Access Compliance Report Public Rights-of-Way (Curb Ramps)

Main Street: WOODBRIAR Cross Street: UNIVERSITY_AVE Location: NW

ADA ID: RPRK220223152150 Ramp Type: Type 4 - Parallel Initial Pass/Fail: Pass Overall Compliance: No Severity Score: 25

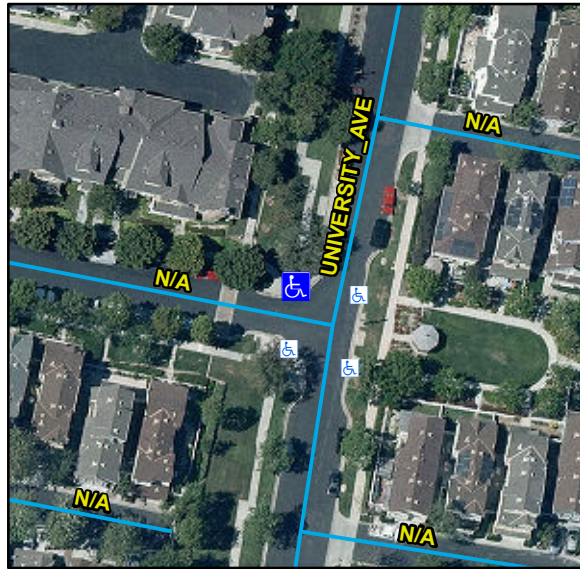
N/A	Ramp Inside Crosswalk 1	N/A	N/A	Ramp Inside Crosswalk 2	N/A
	Crossing 1 Slope (%)	3		Crossing 2 Slope (%)	1.7
	Crossing 1 Cross Slope (%)	0.6		Crossing 2 Cross Slope (%)	3
Yes	Gutter Ponding	No	Yes	Curb Slope	2.6
Yes	Gutter Lip Height (in)	0		Road Run Slope (%)	2.8
No	Gutter Run Slope (%)	6.6		Road Cross Slope (%)	0.8
Yes	Gutter Cross Slope (%)	1.7	No	Perpendicular Joint Present	No
Yes	Overall Surface Condition	Acceptable			
	Cross Gutter Present?	No		Spandrel Present?	No
	Replace Cross Gutter?	N/A		Replace Spandrel?	N/A

Remove & Replace Curb Ramp With Two New Directional Ramps or Equivalent. Remove & Replace Gutter.
